CERTIFICATE OF APPROPRIATENESS

Property: 1913 B Crockett St, Lot 11A, Block 314, Shearn Addition Subdivision. The property is a vacant interior lot, subdivided into two lots, Lot A that measures 2,534 square feet (51' x 50'-4") and Lot B that measures 1,608 square feet (37'-8" x 42'-8").

Proposal: New Construction – Residence

ATTACHMENT A

NORTH ELEVATION – FRONT FACING CROCKETT STREET
PROPOSED

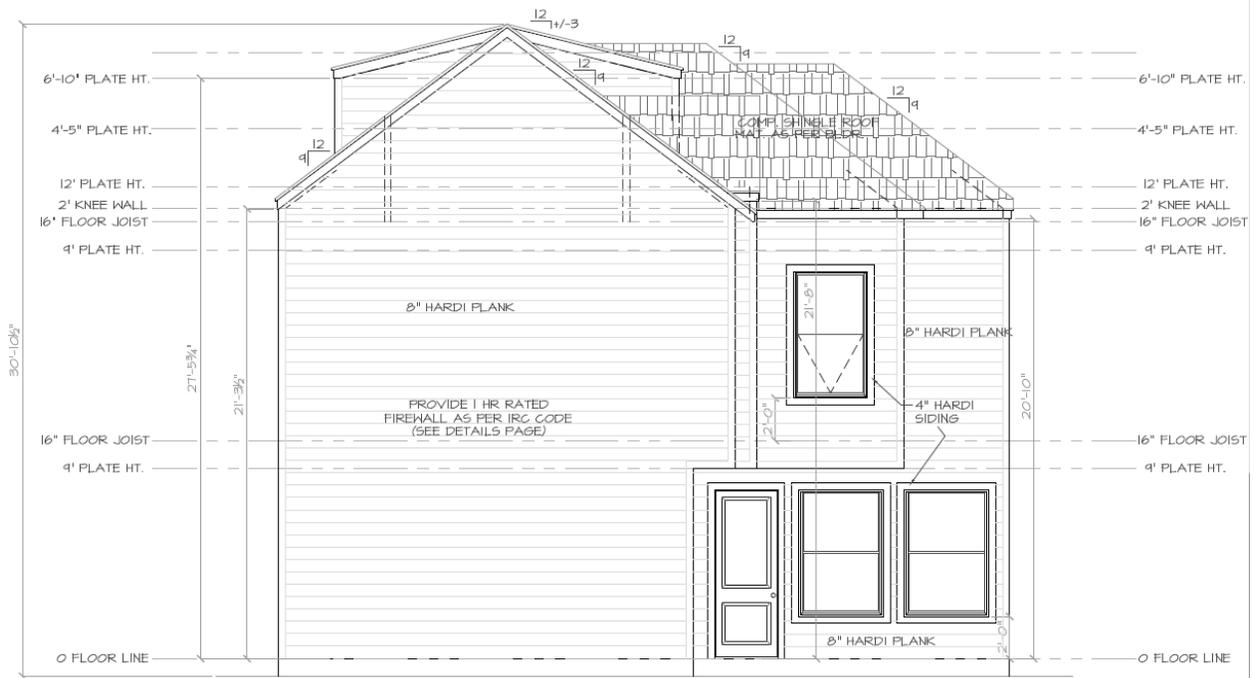
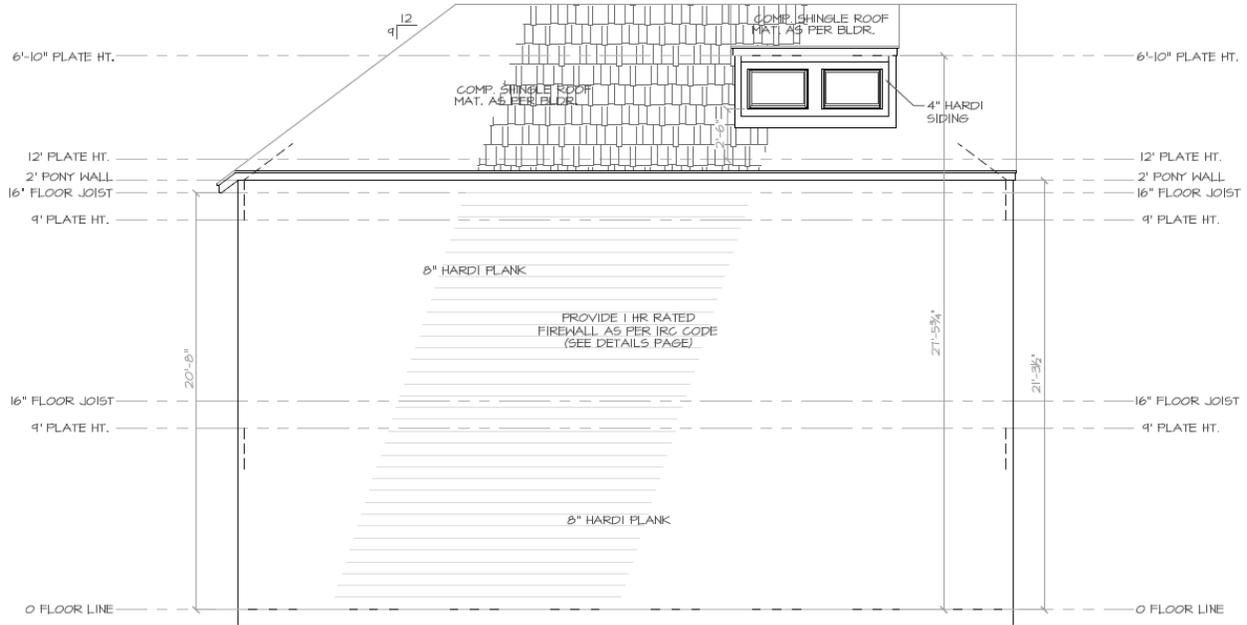
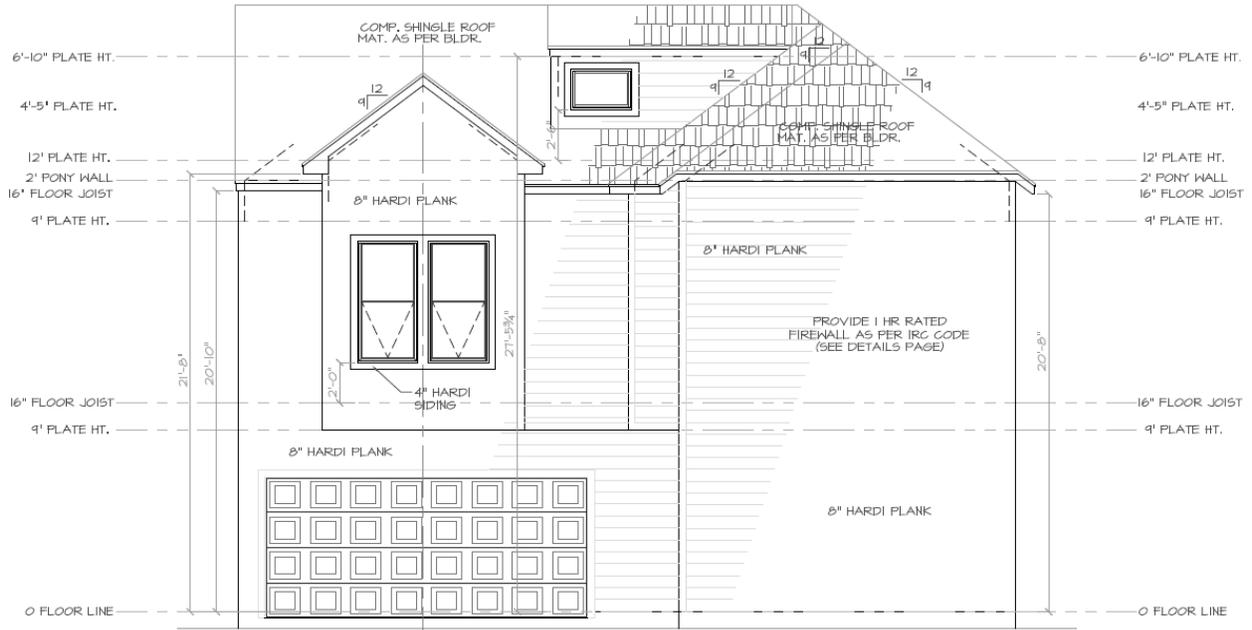
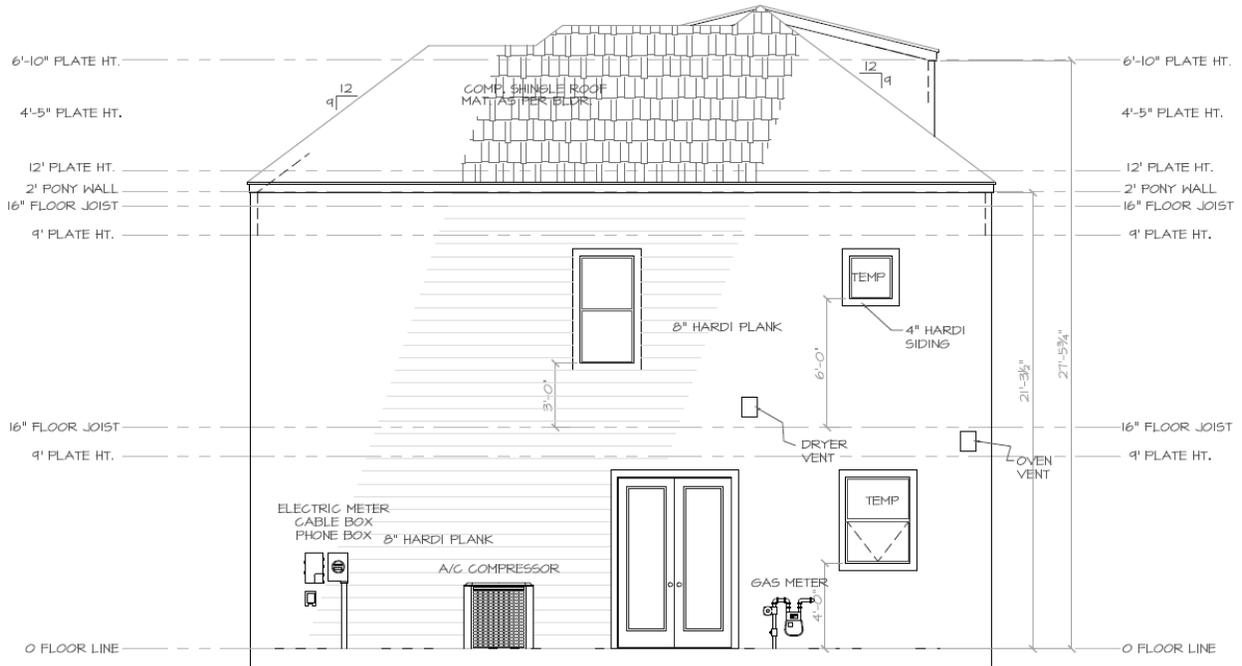
- 2.2. In addition, several of the proposed structures (1911A, 1911B, 1913B) stretch the definition of what can be considered a two-story structure. By incorporating dormers (in order to capture additional living space in an area which in a traditional historical structure would be an unfinished attic), they create additional massing, worsening the contrast with and dwarfing of 1907 Crockett and the other contributing structures. These proposed new buildings are really two-and-a-half-story structures.

- 3.1. 8" hardie plank has been specified throughout. This material is cheap-looking and not in keeping with the historic structures in the District. 4" plank should be used instead. Additionally, the texture of the planks to be used is not noted; flat-texture planks should be used.
- 3.2. Glass block has been specified in all of the designs. This material does not seem appropriate for a historic district.
- 3.3. Many of the windows in the designs are large, single-pane fixed windows. This type of window does not seem appropriate to this historic district. 1-over-1 and 2-over-2 double-hung windows are the norm in this district.

- 4.1. On a number of the sides of the proposed structures, there are no windows at all. This is out of character for the contributing structures in the District.
- 4.2. Many of the rooflines are excessively complicated and thus not compatible with the contributing structures in the District.

SITE PLAN
EXISTING

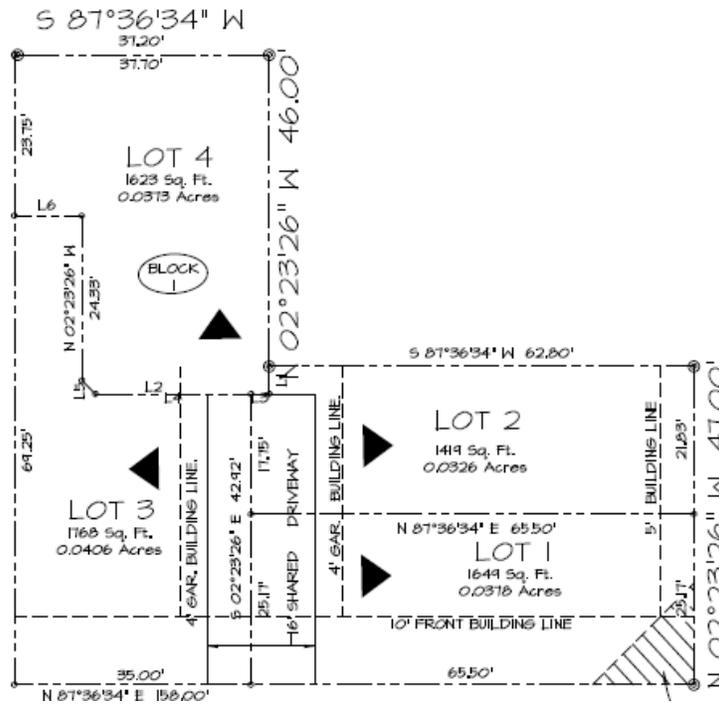
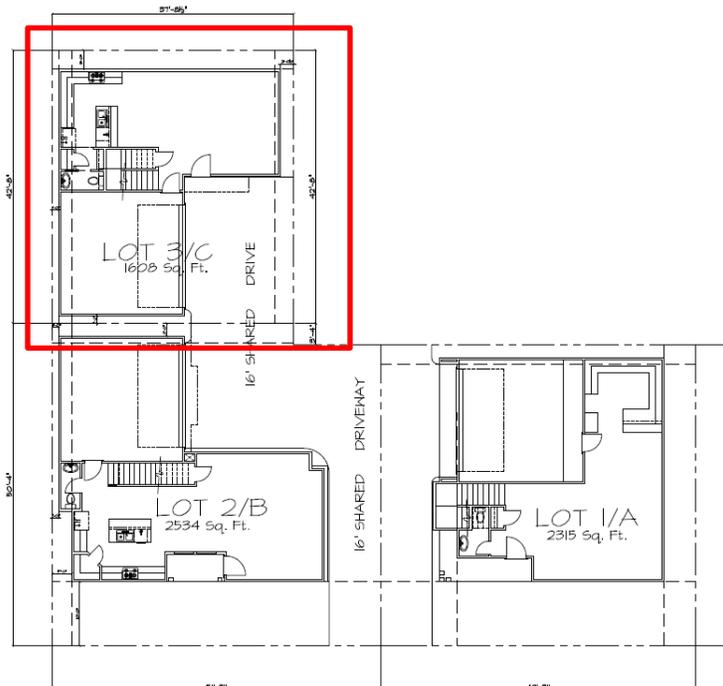
- 1.1. A site plan is required for a COA application. Each of these applications includes a drawing labeled "Site Plan". However, these purported site plans do not indicate the orientation of the proposed buildings to the surrounding streets or to each other. In addition, the elevations are listed as "left", "right", etc. instead of the usual "north", "south" etc. All this is contrary to industry standards, and makes the site plans very difficult to decipher. This needs to be addressed in order to make the proposed plans more readily understandable.

- 1.2. Given the close proximity and interrelationships of the proposed buildings with one another, a site plan should be provided that covers all the buildings in the project so that what is being proposed can be understood.

- 1.4. The historic/contributing structure at 1907 Crockett is known to encroach on its neighbor to the west (1913 Crockett). This encroachment is not shown on the site plan. This omission is significant, since it affects the actual distance that will separate the new structure at 1913 from the existing one at 1907.

- 1.5. A 10' setback from the street is noted. This is out of character for the District, where setbacks of 15 feet or more are prevalent on contributing structures. Is this permissible?
